MINERALS PROGRAM INSPECTION REPORT
PHONE: (303) 866-3567

MINE NAME: Pueblo East Pit	MINE/PROSPECTING ID#: M-1906-015	MINERAL: Sand and gravel	COUNTY: Pueblo
INSPECTION TYPE: Monitoring	INSPECTOR(S): Patrick Hennberg	INSP. DATE: October 17, 2019	INSP. TIME: 1000
OPERATOR: Continental Materials Corporation	OPERATOR REPRESENTATIVE: Bruce Humphries	TYPE OF OPERATION: 112c - Construction Regular Operation	
REASON FOR INSPECTION: <input type="checkbox"/> Normal <input type="checkbox"/> Program		BOND CALCULATION TYPE: Complete Bond	
DATE OF COMPLAINT: <input type="checkbox"/> A		BOND AMOUNT: \$2,200.00	
WEATHER: Clear		JOINT INSP. AGENCY: None	
INSPECTOR'S SIGNATURE: 		SIGNATURE DATE: October 27, 2019

INSPECTION TOPIC: Reclamation Success

2019 Annual Report Map
November 7, 2019

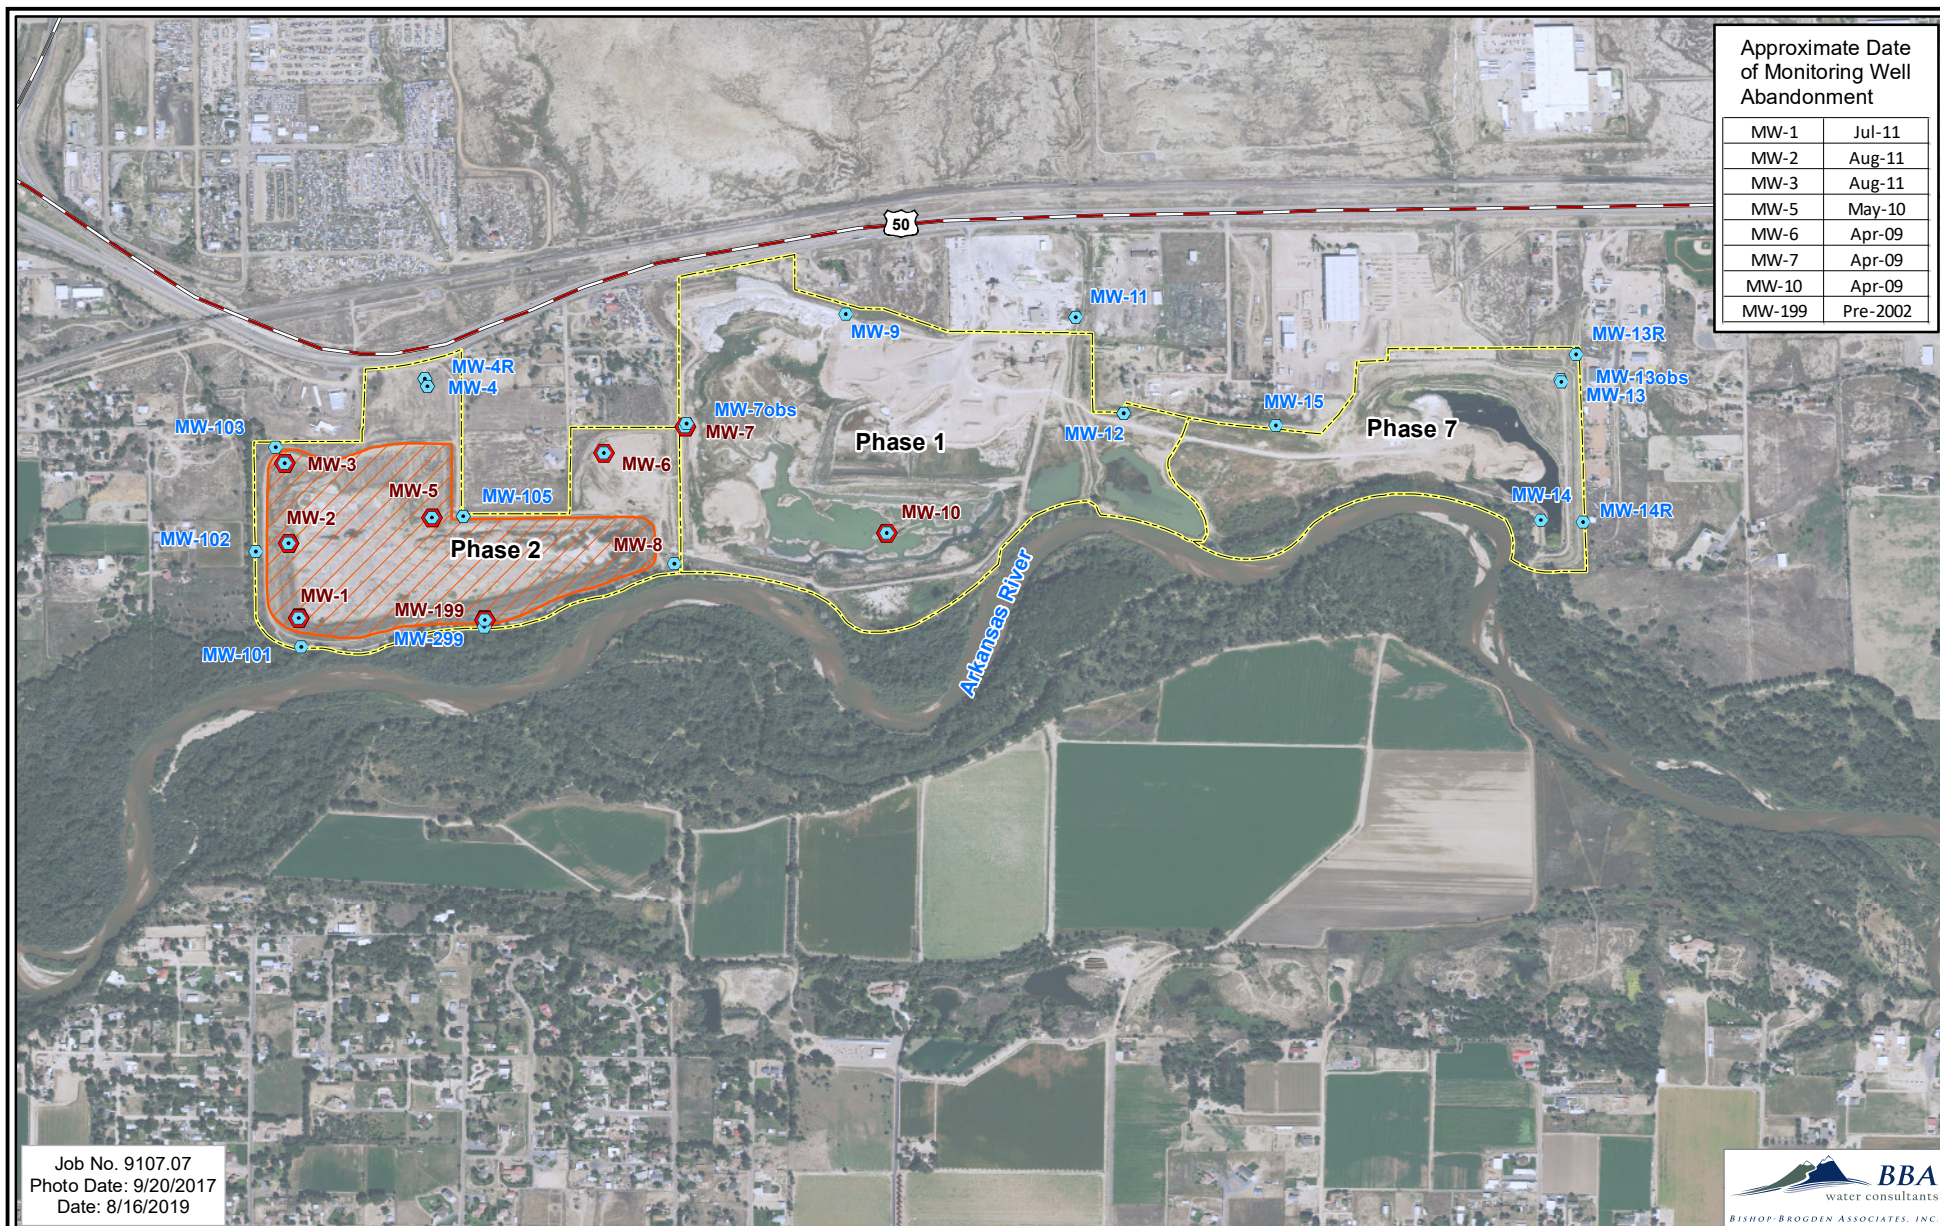
The Pueblo East Pit is located approximately 7 miles east of Pueblo, CO. The access road is the intersection of US Hwy 50 and 26th Lane. Pueblo East Pit is a Construction Materials 112c Operation for 466.16 acres and is approved to affect 268 acres. The affected lands will be reclaimed to a combination of developed water resources, industrial, and wildlife habitat. A map from the 2019 Annual Report (Figure 1) is provided that shows the permit boundary and relevant features within the boundary.

Currently, Phase 1 has a few material stockpiles that are being sold. In 2017 Technical Revision 4 (TR-04) was approved and allowed for the importation of inert fill to be used as backfill. Currently cement truck cleanout material is being used as backfill. As shown in Figure 1 there is approximately 65 acres of exposed groundwater that requires backfilling. The actual depth of the exposed groundwater is not known at this time. According to the reclamation plan approved in Amendment 4 (AM-04) it is assumed that 26 feet of backfill material will be required to get approximately 2 to 3 feet above the groundwater elevation. The slopes of the pit will be graded to 3:1 or flatter. The floor of the basin will be graded to slope to the southeastern corner where an outfall structure will be located to discharge to the river. The post-mining land use for Phase 1 is to be wildlife habitat. Topsoil will be spread 6 to 12 inches on the side slopes. The floor will be left barren for a period of two years to allow for invasion of desired vegetation. If the desired vegetation fails to establish then cottonwood trees and willows will be planted. There are two sediment clean out ponds, totaling about 9 acres, will have to be backfilled above groundwater. At this time it does not appear that there is sufficient backfill and topsoil remaining onsite to complete reclamation, therefore material will have to be imported. The Operator is currently searching for potential sources of backfill.
